LiDAR Quality Assessment Report

Materials Received: 11/8/2011	Project Type: Donated Data
Project ID: WA_KittitasCounty_2010	Project Description:
Project Alias(es):	Year of Collection: 2010

WA_KittitasCounty_2010

[Checkpoint Distribution Image?](#)

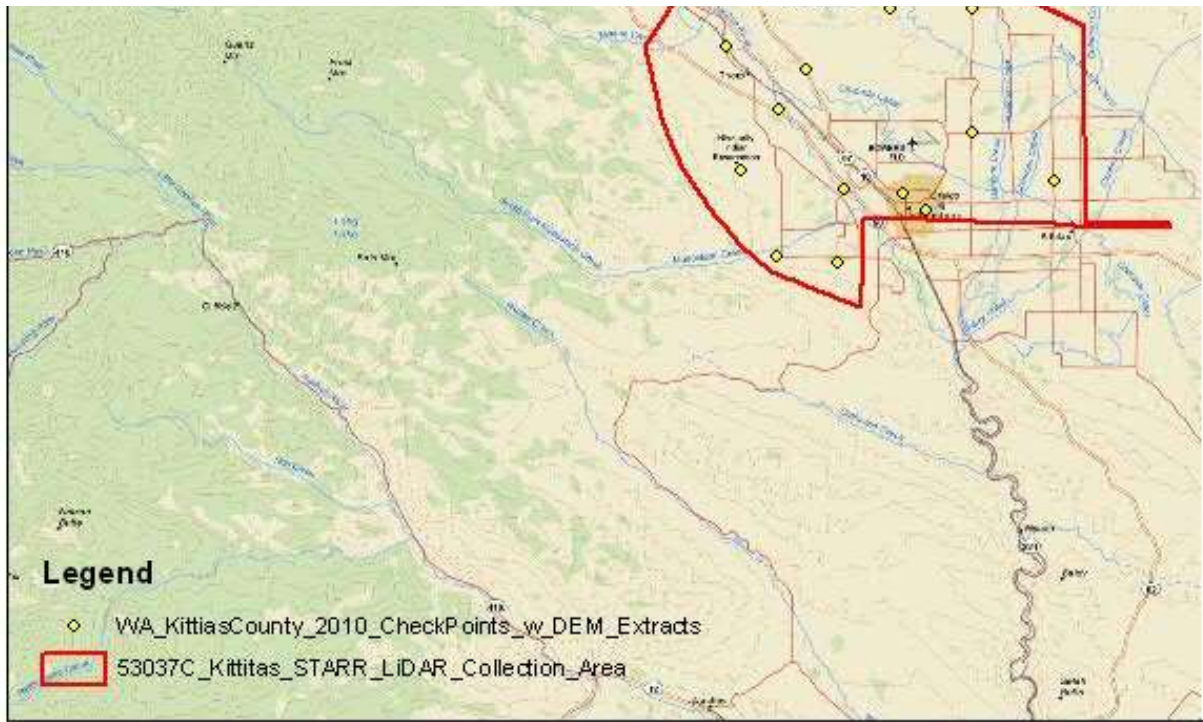
There are a minimum of 20 checkpoints for each land cover class represented. Points within each class are uniformly distributed throughout the dataset. USGS was able to locate independent checkpoints for this analysis. USGS accepts the quality of the checkpoint data for these LiDAR datasets.

Regarding their Reported Vertical Accuracy: The CVA Methodology states there were 20 points made up of SVA areas, CVA should be all points (all SVA points and all FVA points). Moreover, for the SVA land categories in this project (Urban, Forested) only 20 points were gathered. There need to be at least 20 points per SVA land category. Lastly, Referece was just made to CVA, SVA, and FVA, put there was no indication in any shapefile or table what landcover type each point belonged to. As all control points are under the 24.5 cm NSSDA the data is good, but the control points could have been laid out better.
